UNITED STATES
NUCLEAR REGULATORY COMMISSION
REGION II
101 MARIETTA STREET, N.W.
ATLANTA, GEORGIA 30323

EXAMINATION REPORT - 50-416/OL-89-01

Facility Name: Grand Gulf 1

Grand Gulf Requalification Examination
Response to Facility Changes to Answer Key
Week I

Figure 1

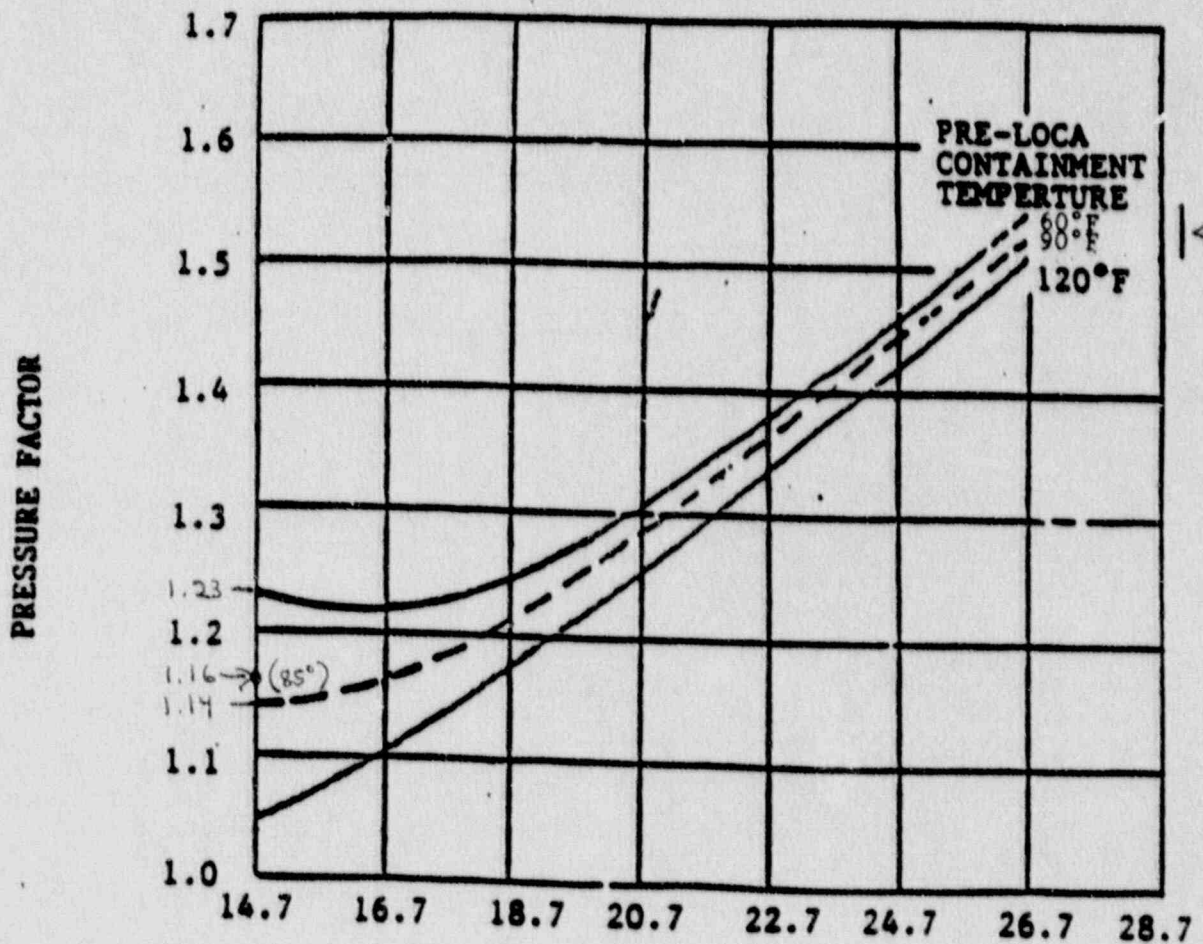
Facility changed the answer to part a from 50.0 to 52.9 due to a revision to the procedure.

(procedure revised 9-21-89)

1.16 thru interpolation

NRC will accept the change and grade accordingly.

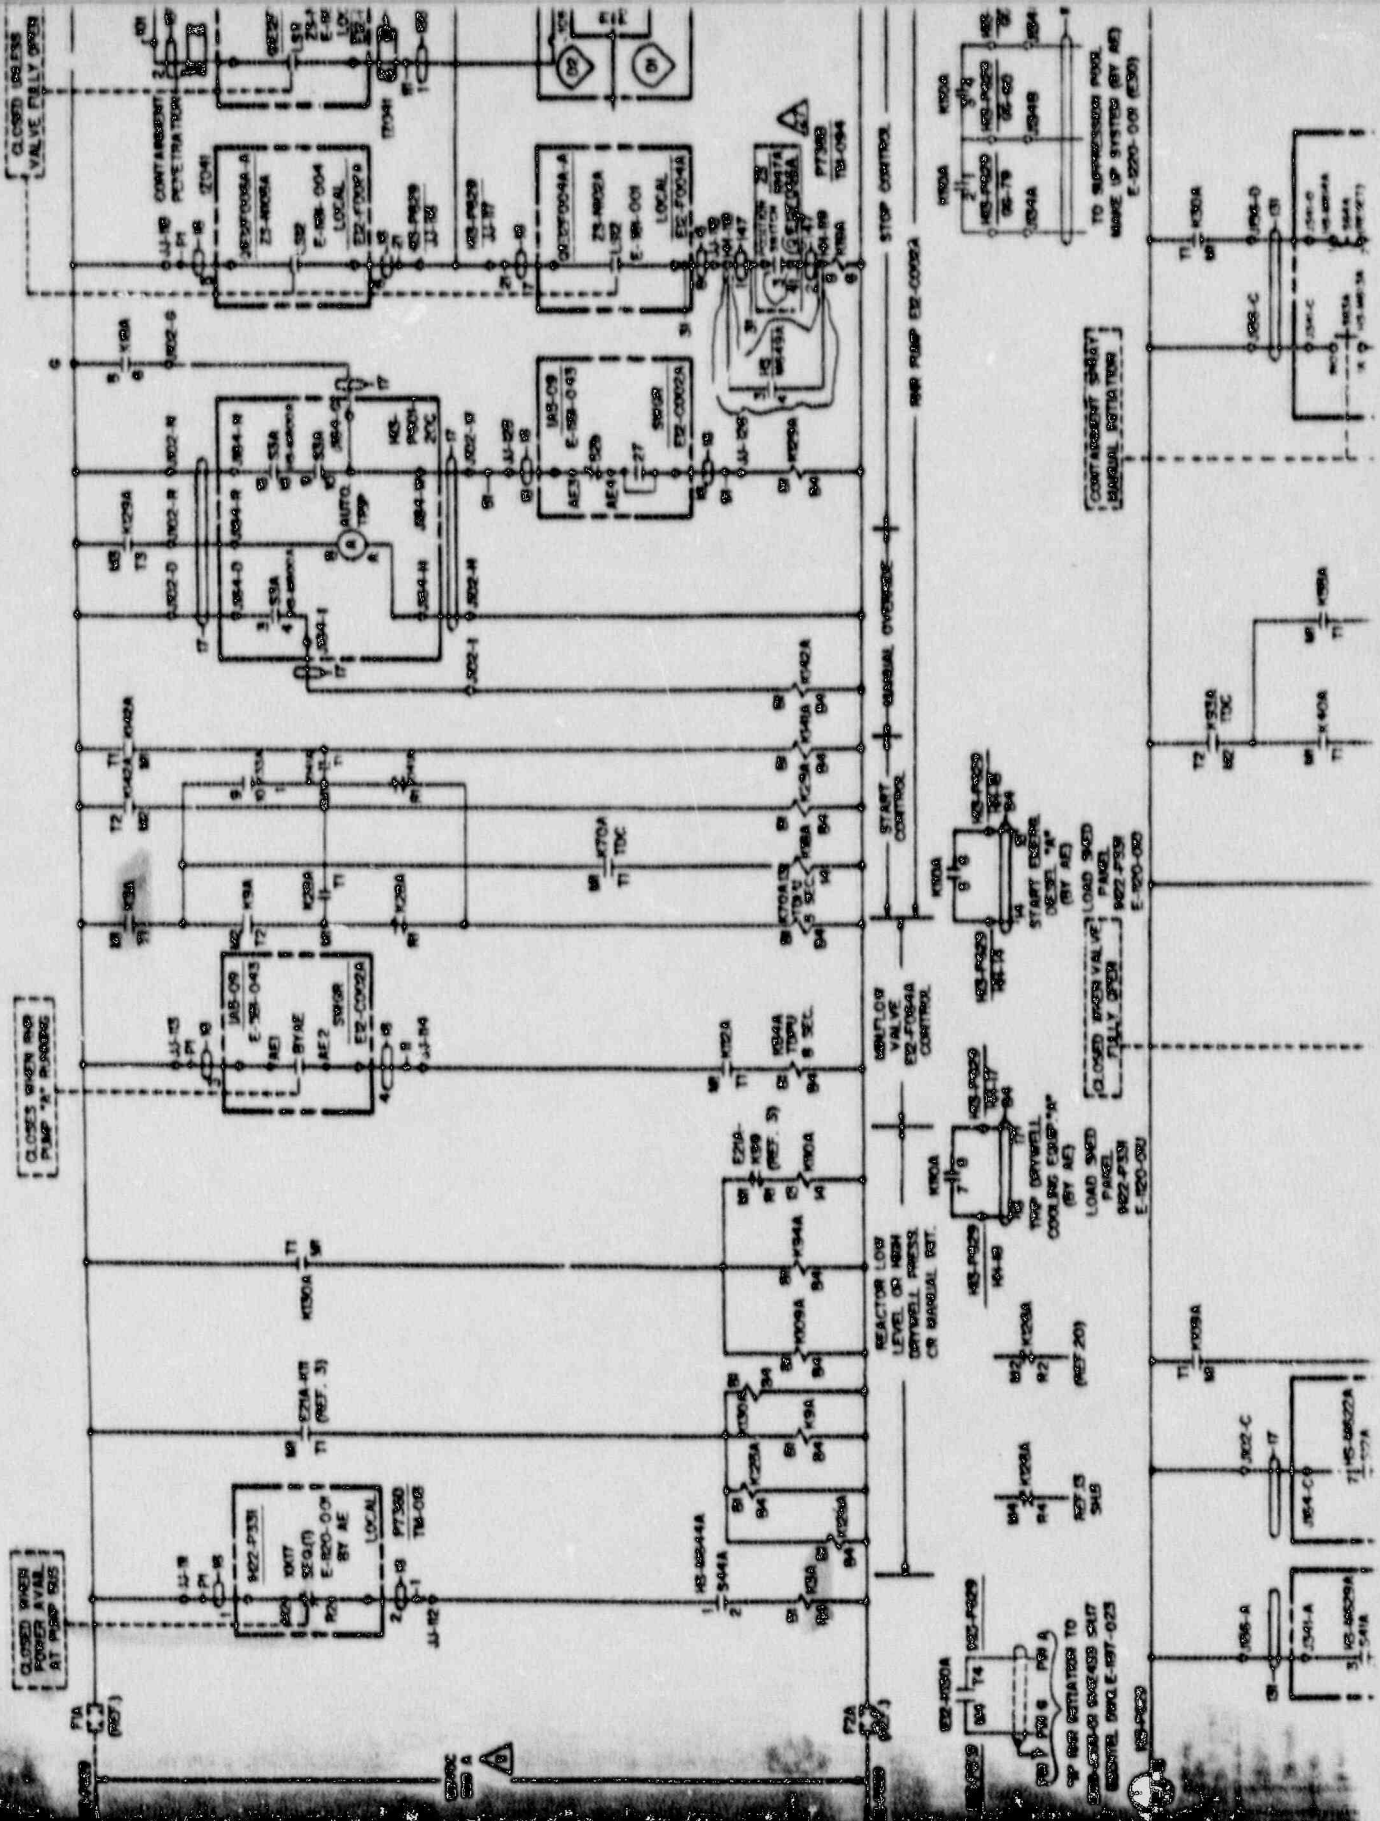
"Div I" not required for full credit.

Examinees would demonstrate adequate knowledge of question by simply stating containment spray initiation signal. Div I is stated in question.

NRC Response: NRC will accept the both changes and grade accordingly.

REC'D 583

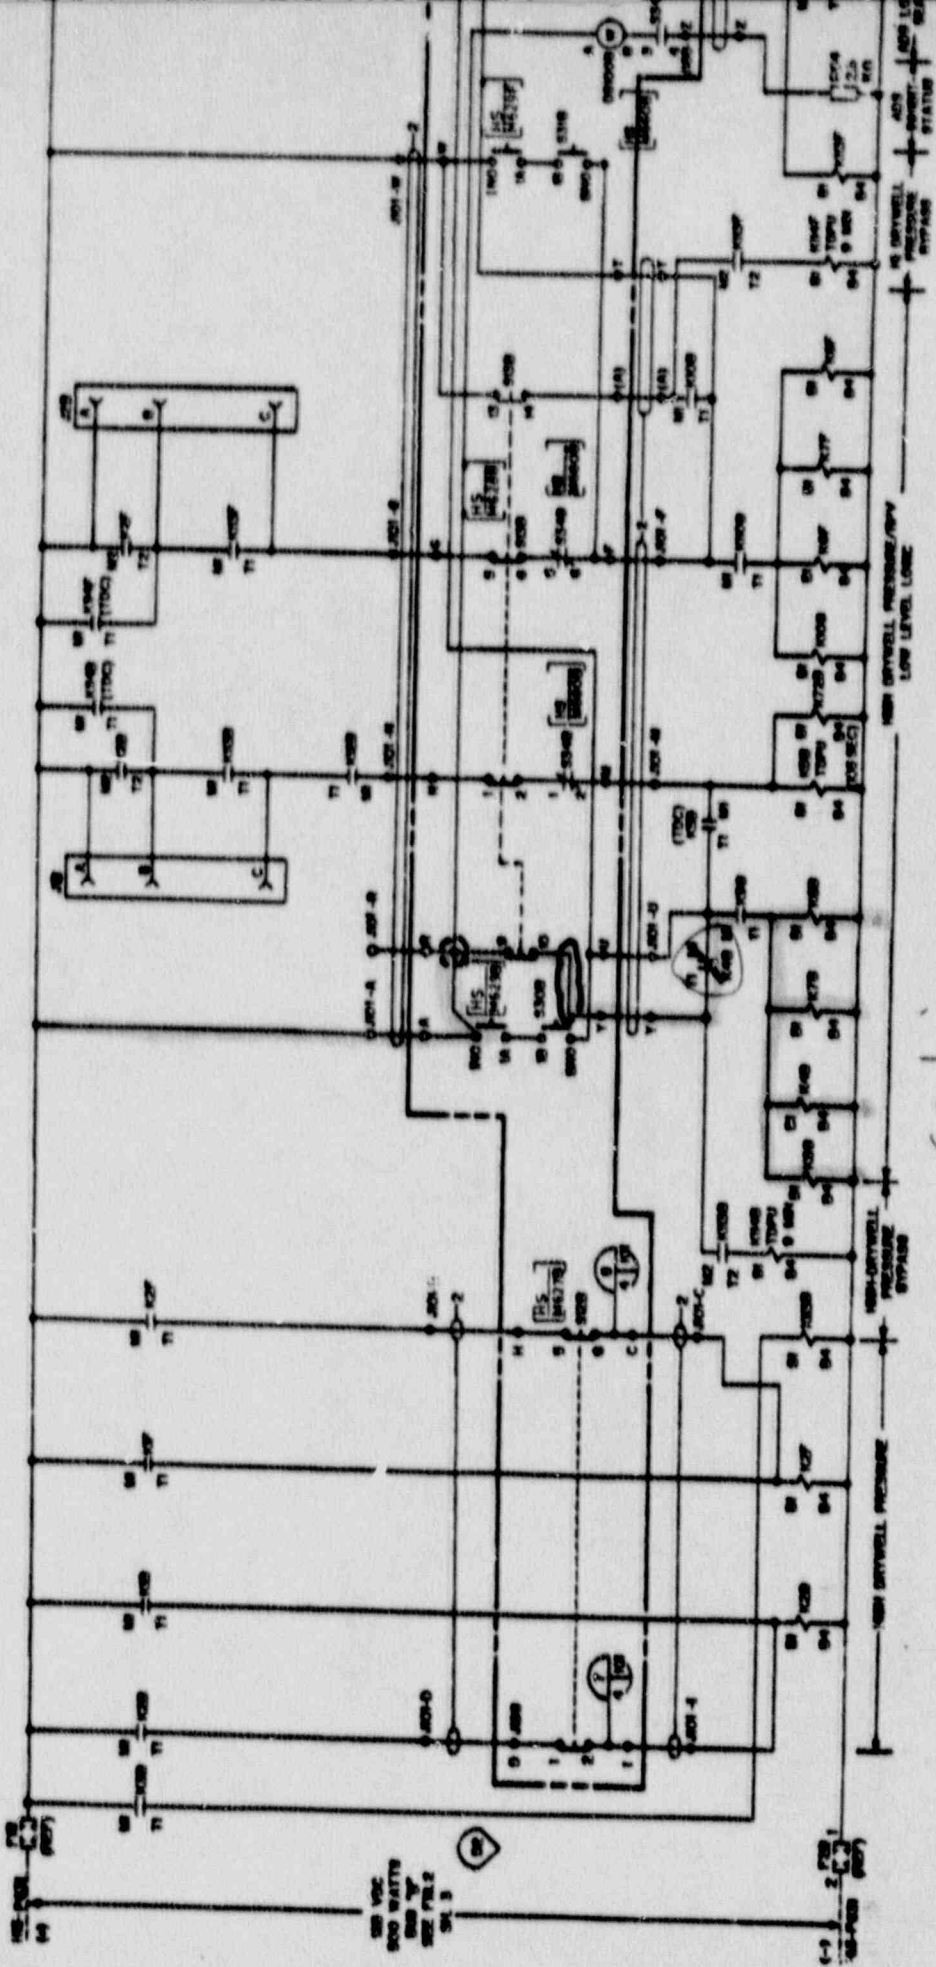
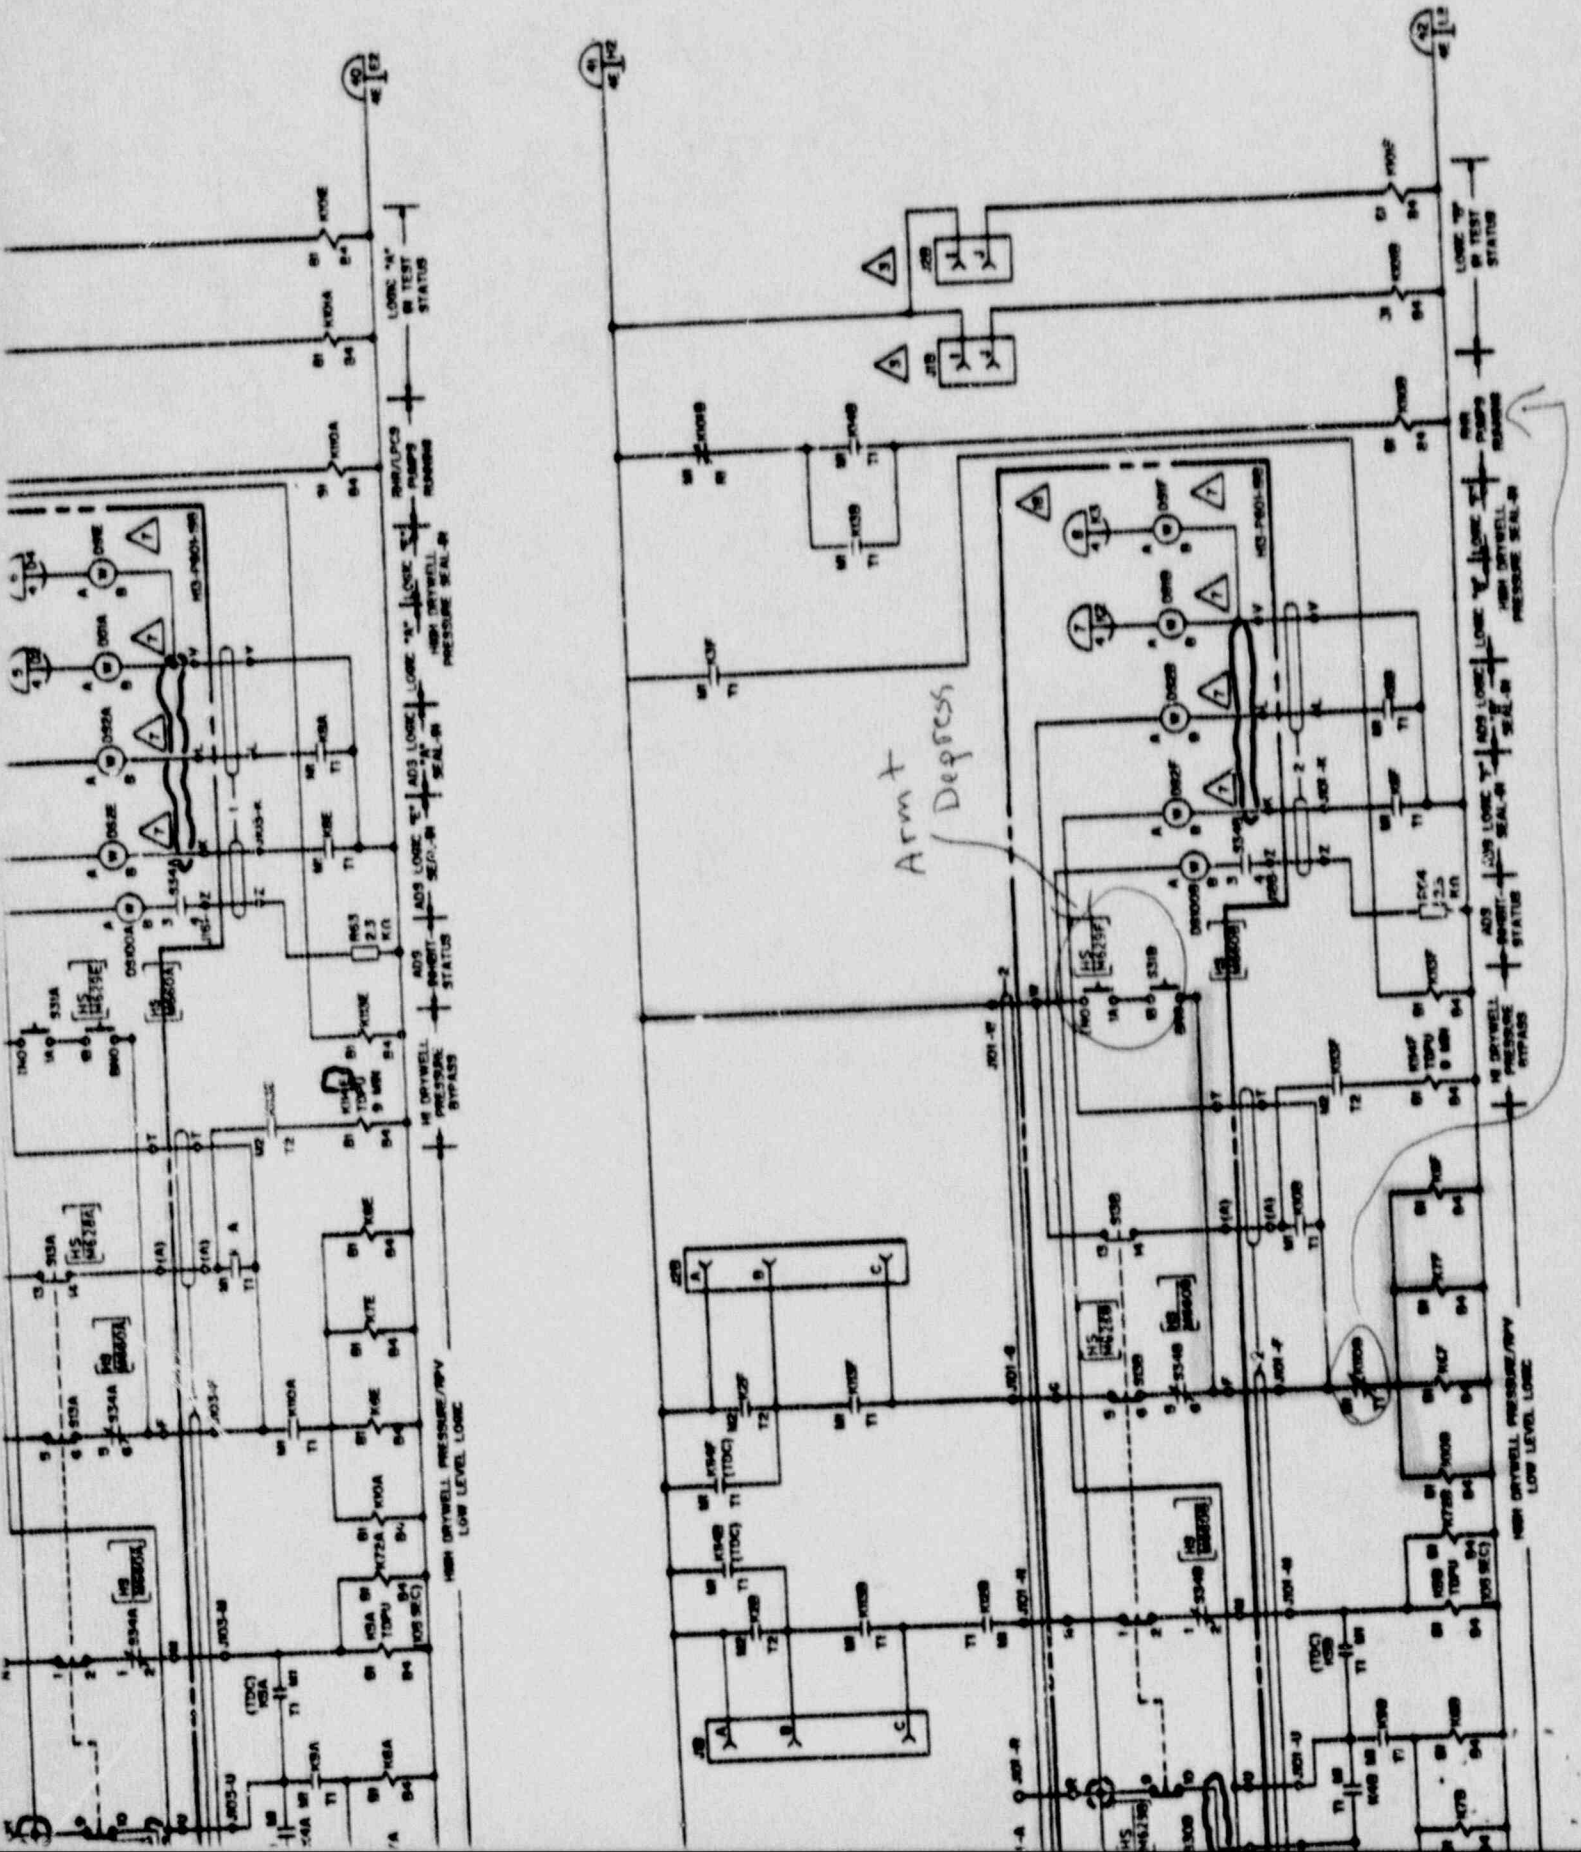
Facility changed the answer to "accept arm and depress F only." Justification is that the "B" subchannel logic is sealed-in from the valved out transmitter so "F" is the only button required to initiate the "B" ADS.

Seal in on
Subchannel 'B' logic

Arm + Depress

NRC Response: NRC will agree to the change and will grade accordingly.
